Access Compliance Report

(Curb Ramps)

Intersection ID: 14078	Main Street: EAST_BV	Cross Street: SOUTH_BV	Location: NW
ADA ID: F5813C53608F	Ramp Type: Perp	Initial Pass/Fail: Fail	Overall Compliance: No
Severity Score: 12.5			
Codes/Mitigation Info/Possible Solution		Field Measurements/Component Compliance

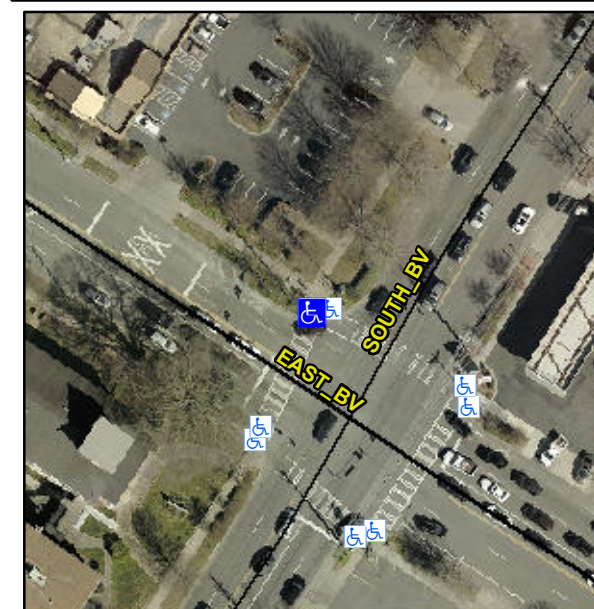
Not Found, R304.5.3

Compliance	Description	Data	Compliance	Description	Data
N/A	Ramp Length (in)	71.0	Yes	Ramp Slope (%)	6.3
Yes	Ramp Width (in)	48.0	No	Ramp XSlope (%)	5.6
N/A	Flare Type LT	N/A	N/A	Flare Type RT	N/A
N/A	Flare Slope LT (%)	N/A	N/A	Flare Slope RT (%)	N/A
N/A	Flare Traversable LT?	N/A	N/A	Flare Traversable RT?	N/A
N/A	Landing Length (in)	N/A	N/A	DWS Provided?	N/A
N/A	Landing Width (in)	N/A	N/A	DWS Contrast?	N/A
N/A	Landing Slope (%)	N/A	N/A	DWS Length (in)	N/A
N/A	Landing X Slope (%)	N/A	N/A	DWS Full Width?	N/A
N/A	Landing Curb? (Y/N)	N/A	N/A	DWS Offset (in)	N/A
N/A	Shared Landing?	N/A			
N/A	Gutter Ponding?	N/A	N/A	Gutter Slope (%)	N/A
N/A	Gutter Lip Ht (in)	N/A	N/A	Gutter X Slope (%)	N/A
N/A	Painted X Walk1?	Yes	N/A	Painted X Walk2?	N/A
	X Walk 1 Direction	To SW		X Walk 2 Direction	N/A
N/A	X Walk 1 Width (in)	107.0	N/A	X Walk 2 Width (in)	N/A
	X Walk 1 Slope (%)	3.2		X Walk 2 Slope (%)	N/A
	X Walk 1 X Slope (%)	4.6		X Walk 2 X Slope (%)	N/A

Remove & Replace Entire Ramp.
